Model: 500 sheet Finisher(SR3050)	Date: 26-Dec-07	No.: RD372001a
-----------------------------------	-----------------	----------------

Subject: Firmware Release Note: 500 sheet Finisher(SR3050)		Prepared by: S.Tomoe	
From: 2nd Tech. Support Sec. Service Support Dept.			
Classification:	<input type="checkbox"/> Troubleshooting <input type="checkbox"/> Mechanical <input type="checkbox"/> Paper path <input checked="" type="checkbox"/> Other ()	<input type="checkbox"/> Part information <input type="checkbox"/> Electrical <input type="checkbox"/> Transmit/receive	<input type="checkbox"/> Action required <input type="checkbox"/> Service manual revision <input type="checkbox"/> Retrofit information

Model: R-C5 500 sheet Finisher (SR3050)		Date: 08-Apr-10	No.: RD372002
Subject: PCB short		Prepared by: T. Nihei	
From: 1st Overseas Tech Support Sec., 1st PQM Dept.			
Classification:	<input type="checkbox"/> Troubleshooting <input checked="" type="checkbox"/> Part information <input type="checkbox"/> Action required <input type="checkbox"/> Mechanical <input type="checkbox"/> Electrical <input type="checkbox"/> Service manual revision <input type="checkbox"/> Paper path <input type="checkb

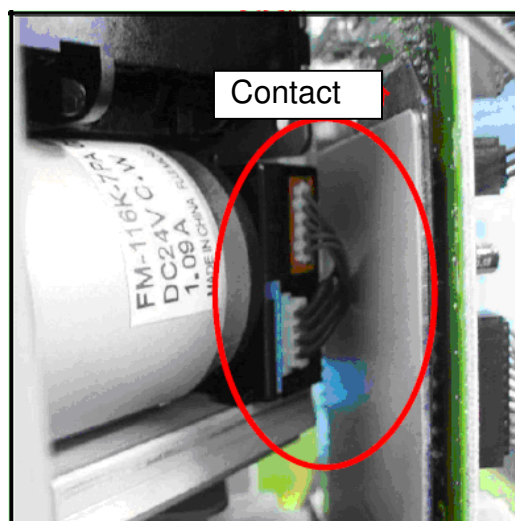
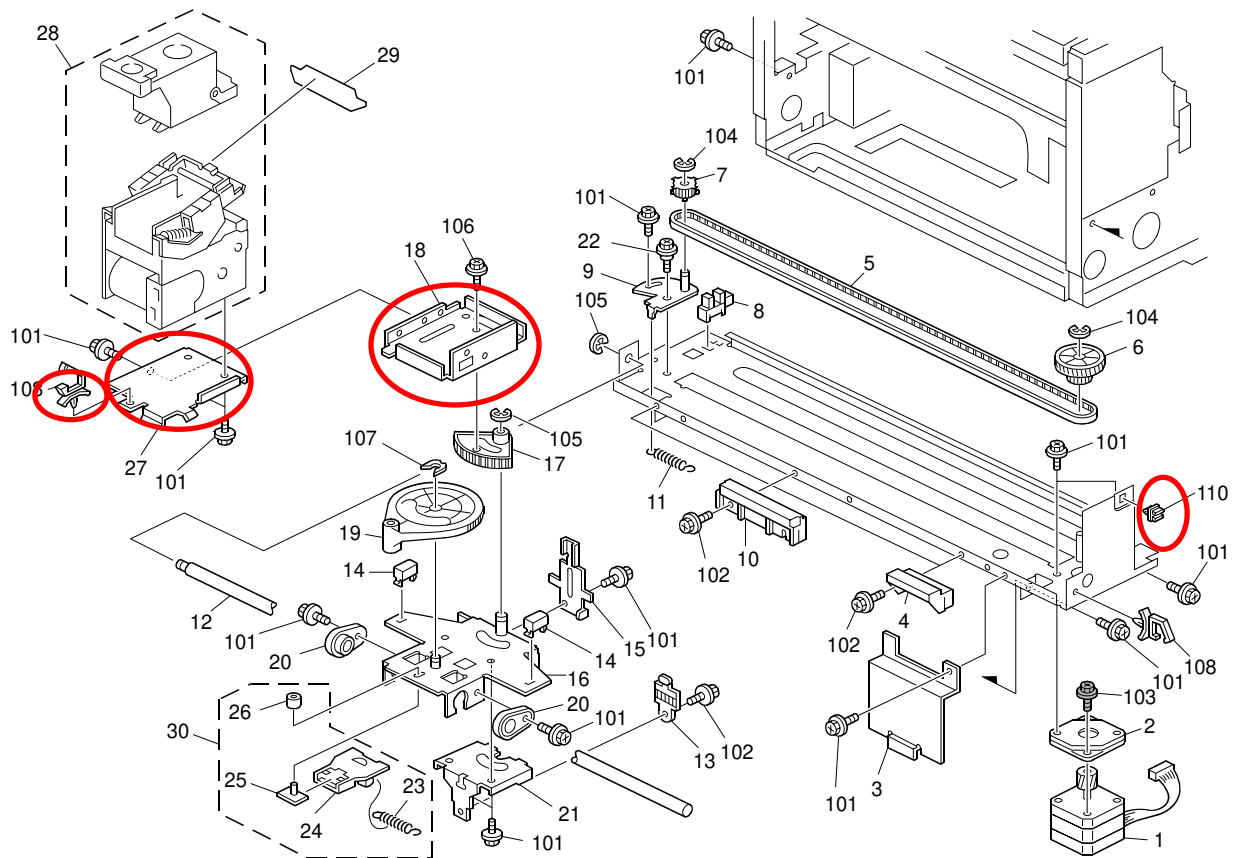
Change:

- 1) An opening was made in the stay.
- 2) A locking support was added.
- 3) The routing of the harness was changed.

Reason: To ensure that the harness does not contact the stay (which can put pressure on the pins of the PCB behind the stay).

Important: When you install the new parts, make sure to reroute the harness as shown on the last page of this RTB.

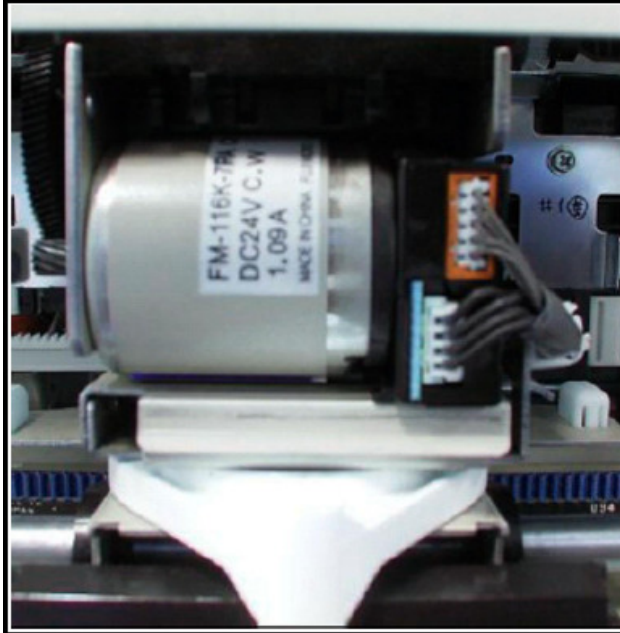
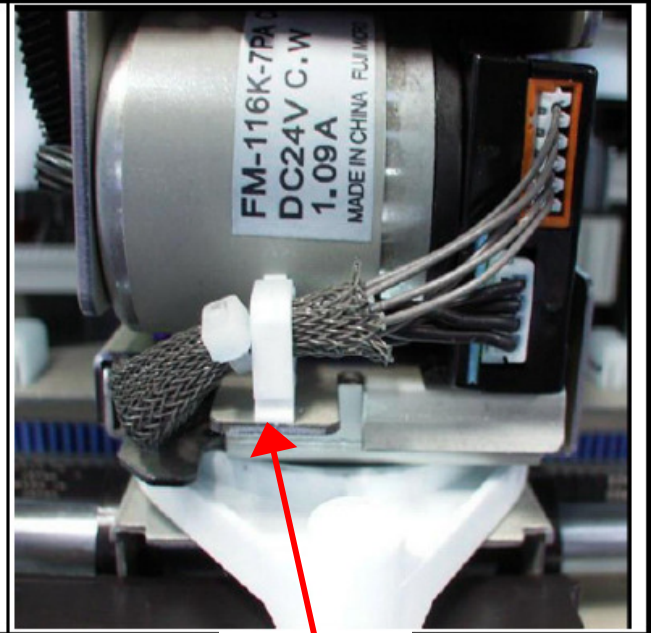
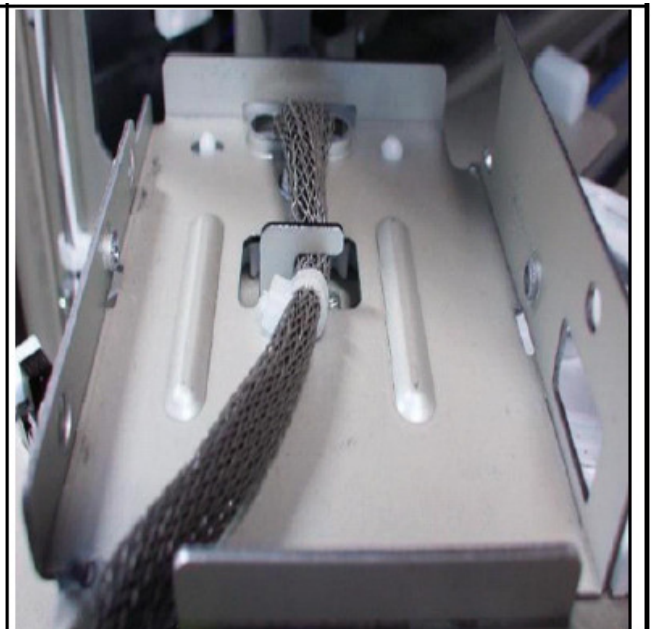
If you install the new parts, reroute the harness as shown in the photos marked "**New**".

Old:

New:

Internal view of bracket D3724567:

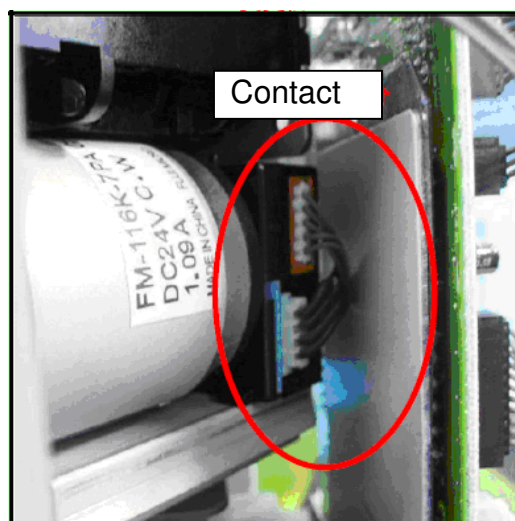
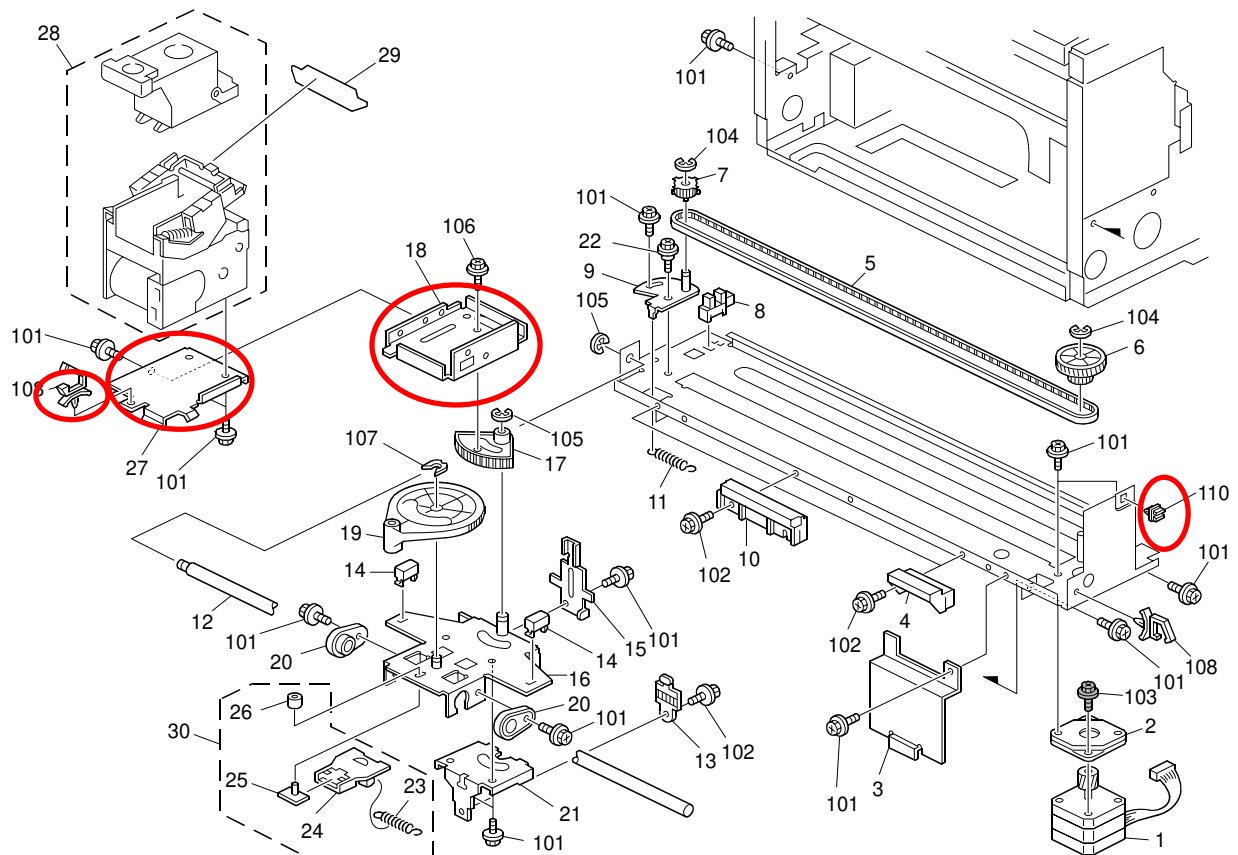
Change:

- 1) An opening was made in the stay.
- 2) A locking support was added.
- 3) The routing of the harness was changed.

Reason: To ensure that the harness does not contact the stay (which can put pressure on the pins of the PCB behind the stay).

Important: When you install the new parts, make sure to reroute the harness as shown on the last page of this RTB.

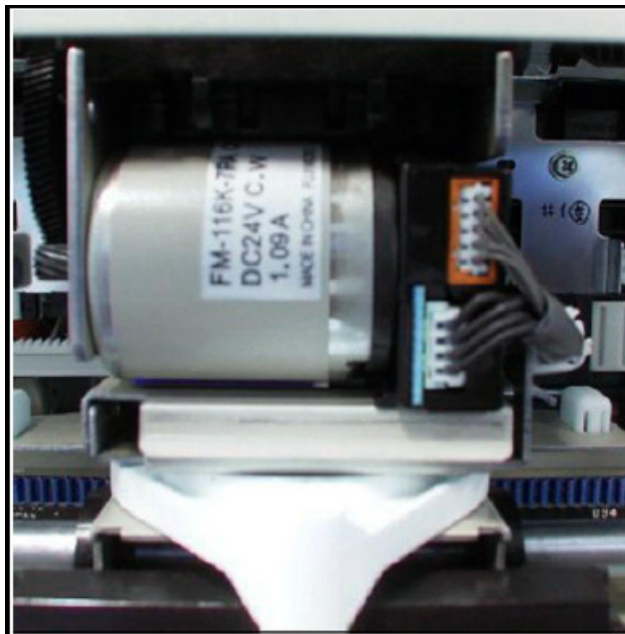
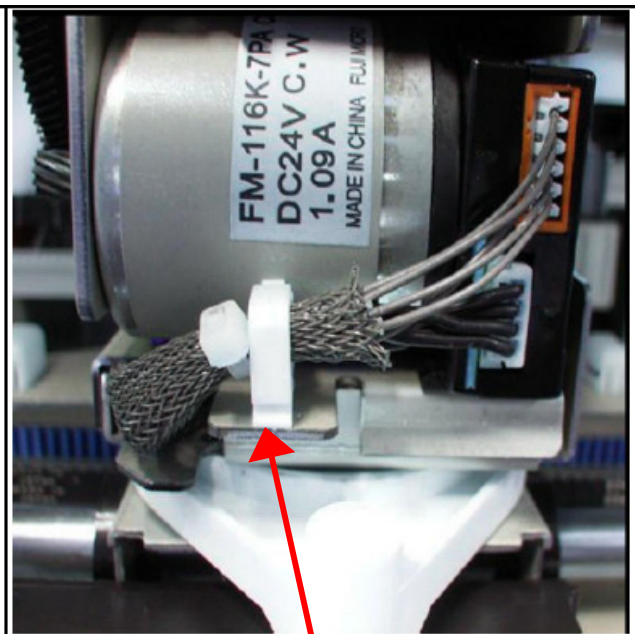
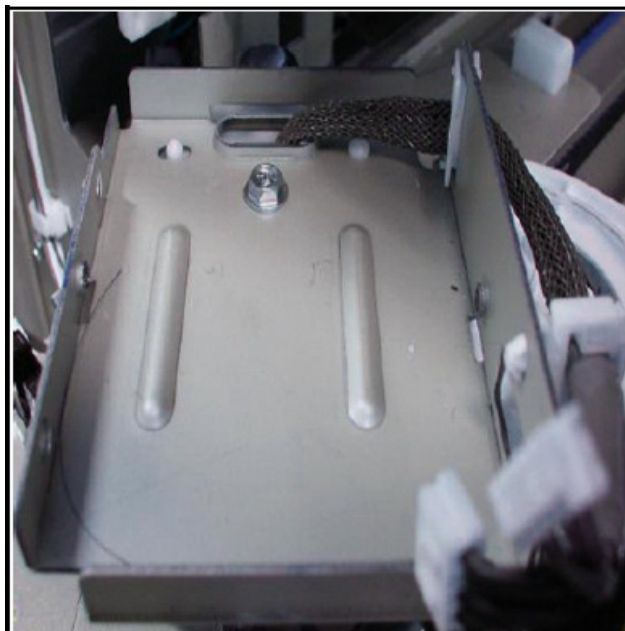
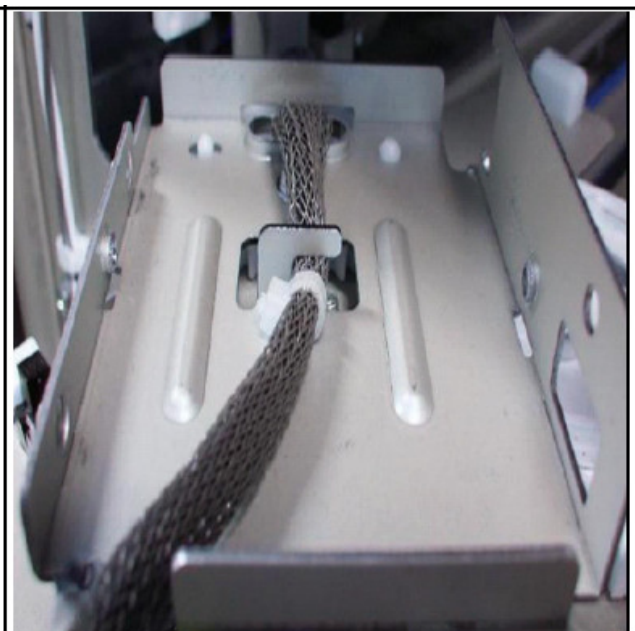
If you install the new parts, reroute the harness as shown in the photos marked "New".

Old:

New:

Internal view of bracket D3724567:

Old:

New:

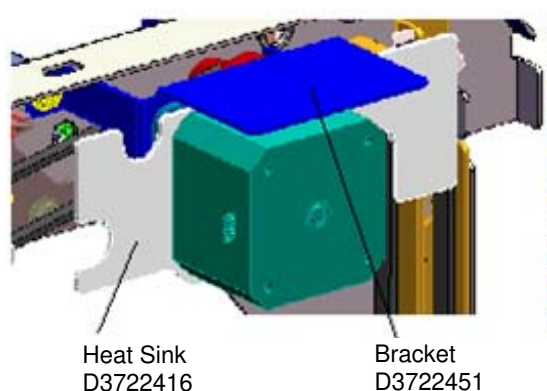
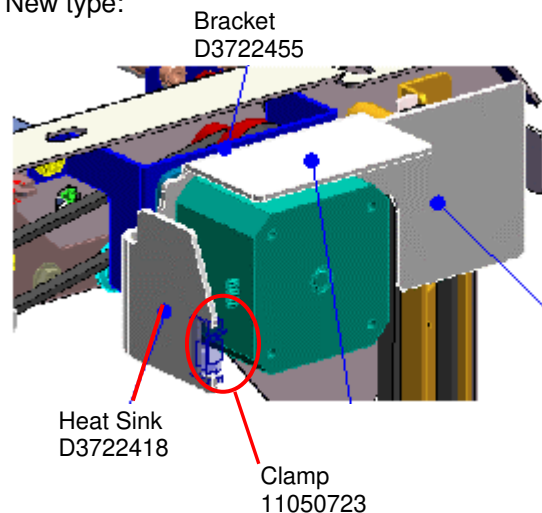
Changes:

- 1) The shapes of the bracket and the heat sink were changed.
- 2) A clamp was added to the heat sink.

Reason: To further increase the resistance to high temperatures.

Old type:

New type:

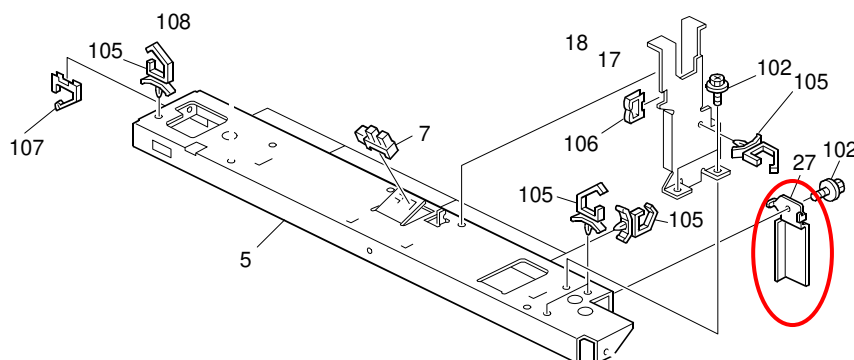
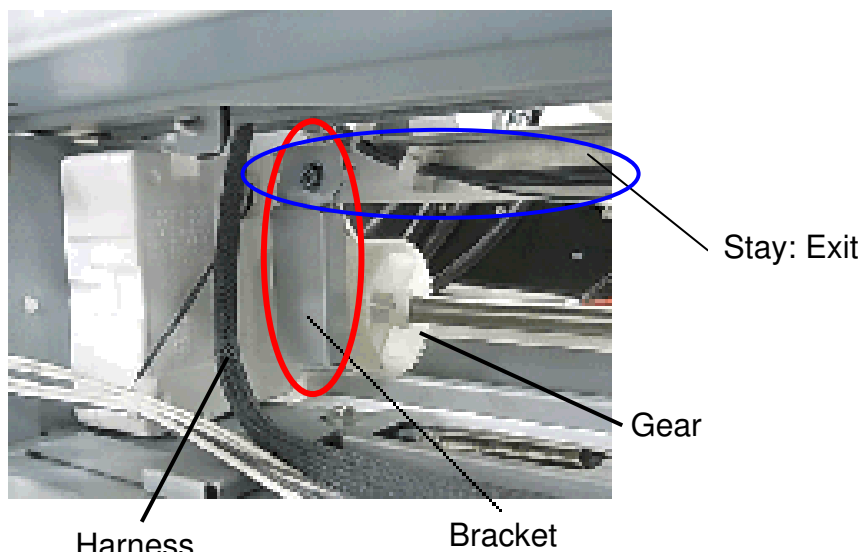
Change:

- 1) A bracket and tapping screw for the harness guide were added.
- 2) The shape of the exit stay was changed (a screw hole was added).

Reason: To further ensure that the harness does not come into contact with the gear.

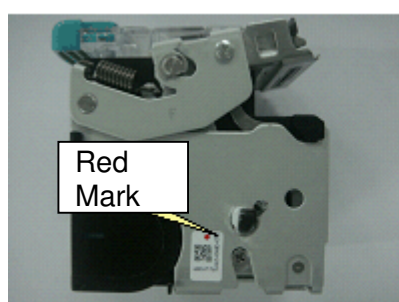
Important: Stapler units on some of these affected finishers have already been replaced with the normal ones. If there is a **red dot** on the stapler unit's label (see the photo below), you **do not need to replace** these units.
